**OU 1 NEX GAS STATION LEAK AREA - DECLARATION OF RECORD OF
DECISION (ROD) AMENDMENT 1**

**DECLARATION OF THE RECORD OF DECISION
AMENDMENT NO. 1
OPERABLE UNIT 1, NEX GAS STATION LEAK AREA
JACKSON PARK HOUSING COMPLEX/NAVAL HOSPITAL BREMERTON**

Jackson Park Housing Complex/Naval Hospital Bremerton
Operable Unit 1, NEX Gas Station Leak Area (formerly identified as Benzene Release Area)
Bremerton, Washington

Figure 1-2
NEX Gas Station Leak Area Location Map

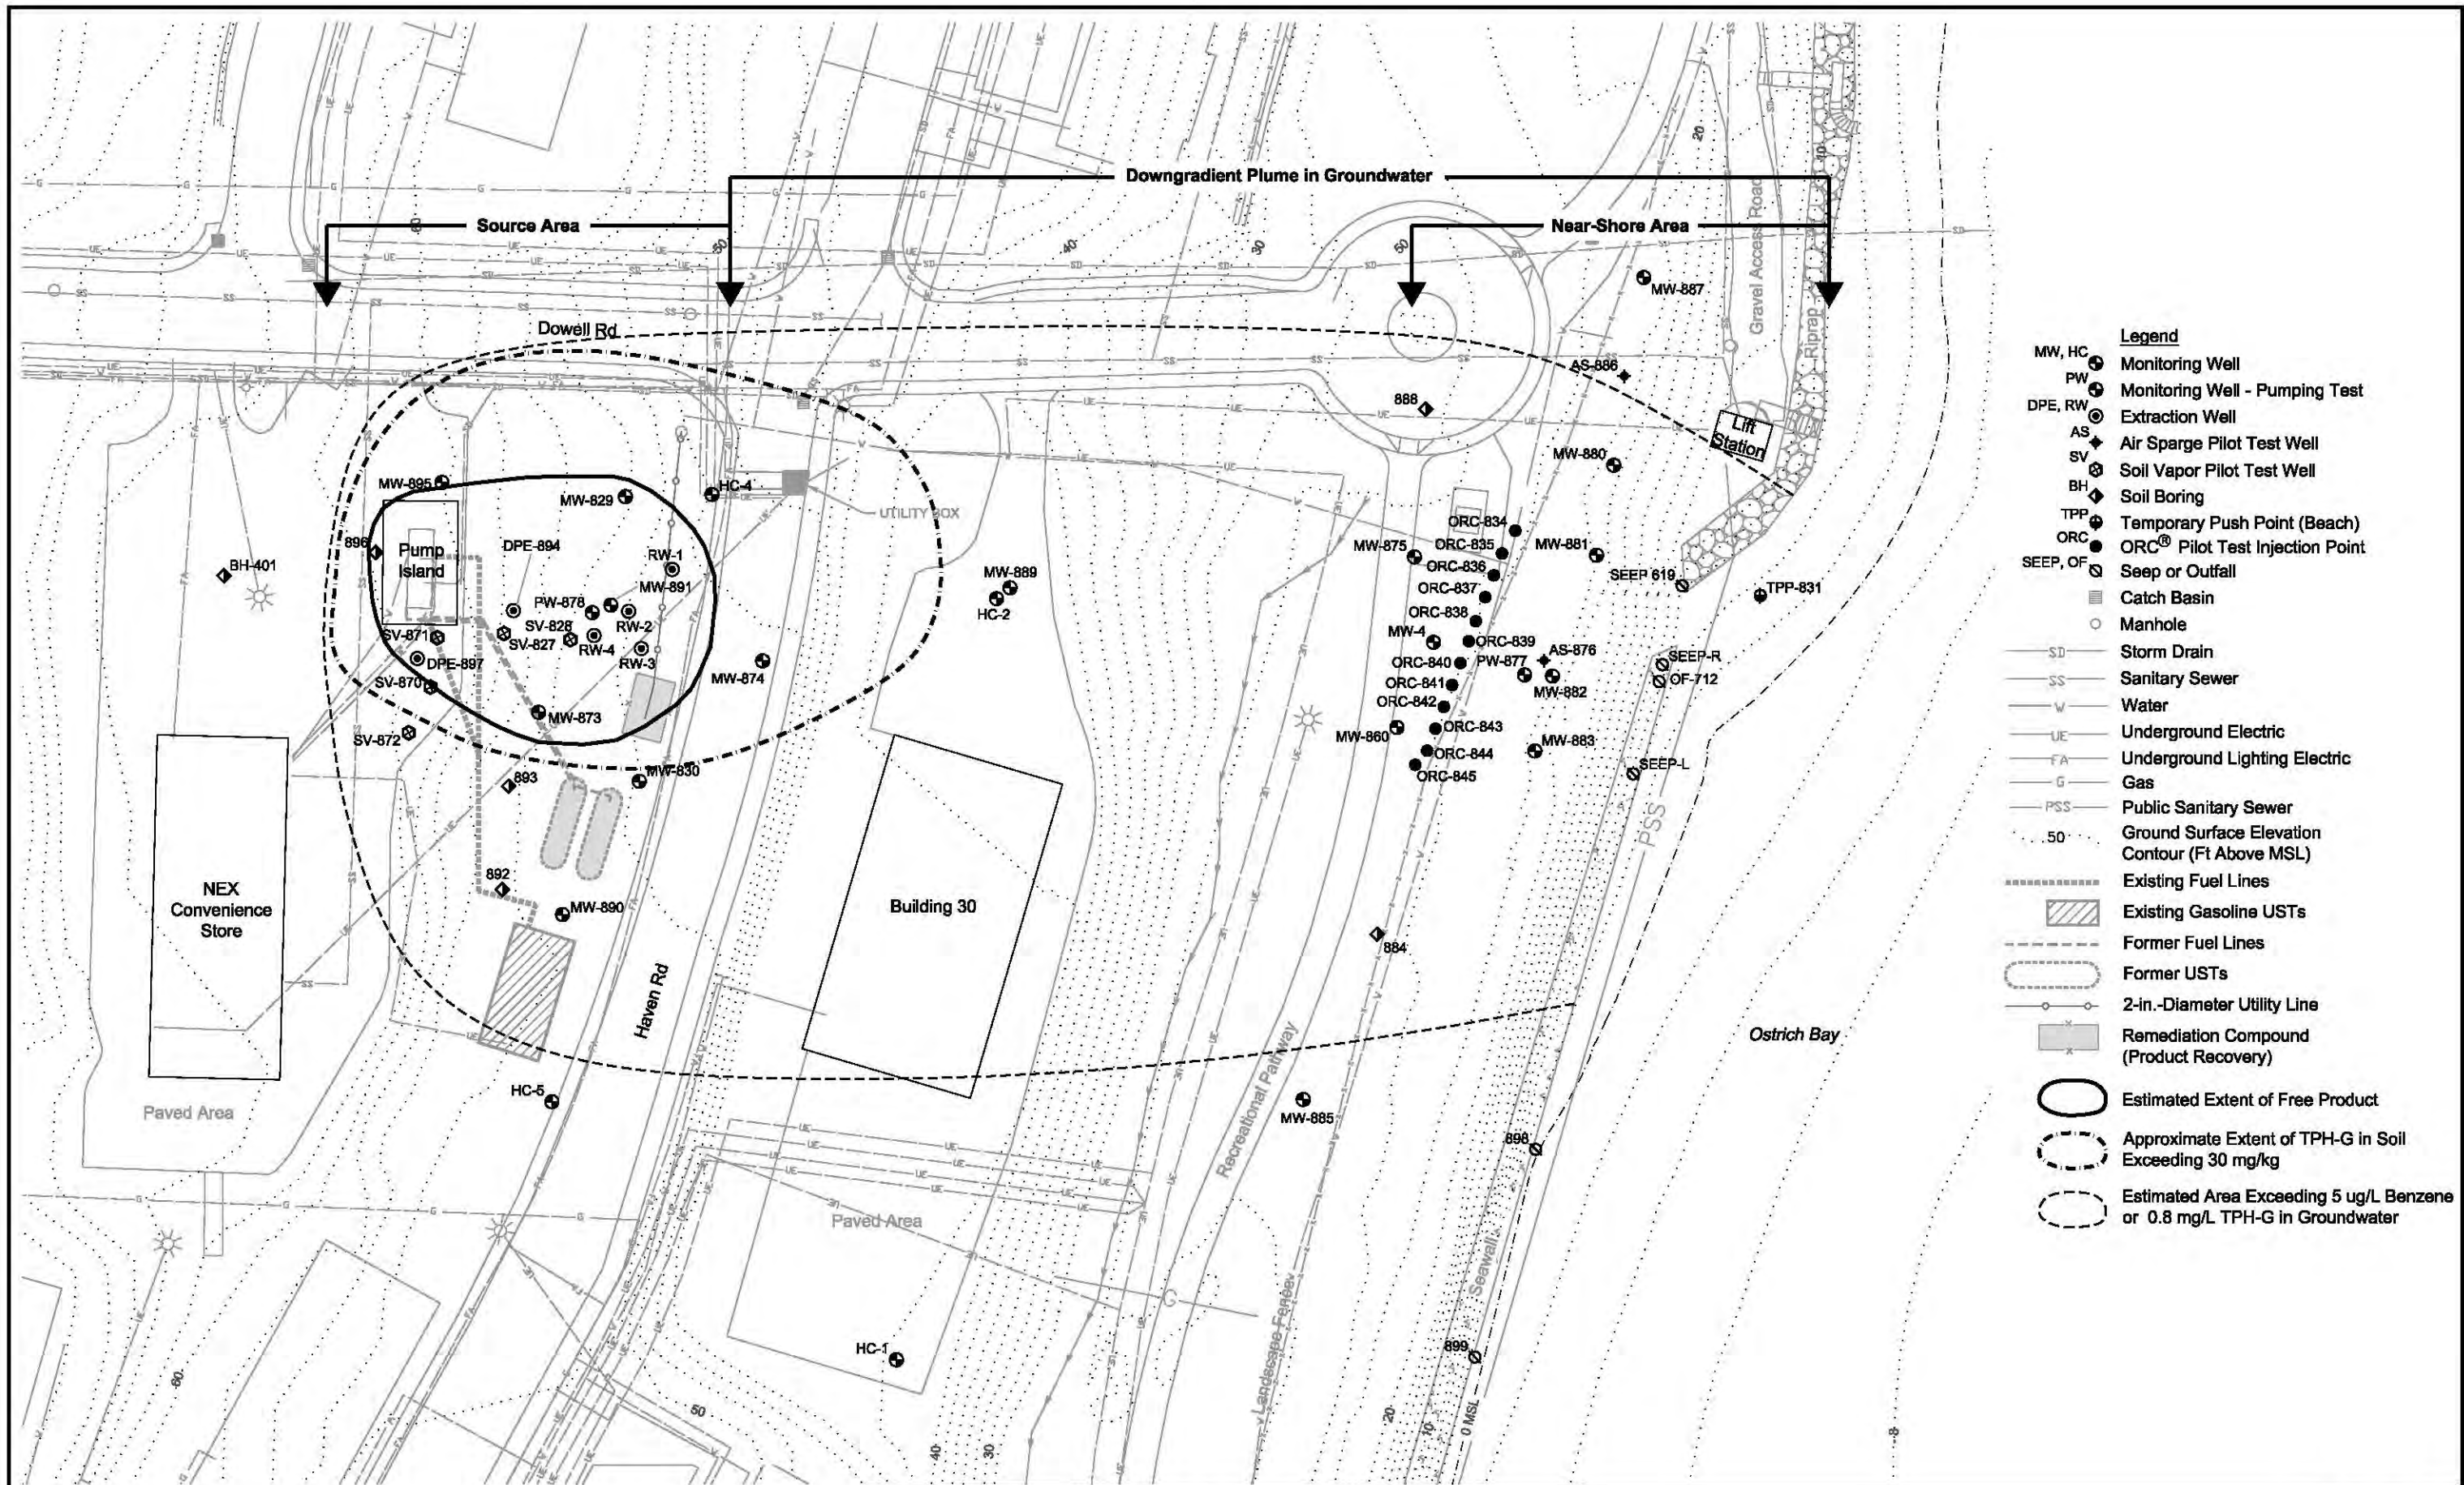
27. Page 4-5, 1st partial paragraph – The contaminated soil in the NEX Gas Station Leak Area is in Site 110 (see figure 1-2) so why wouldn't the RG in the ROD apply? There are similar statements in the ROD Amendment elsewhere.
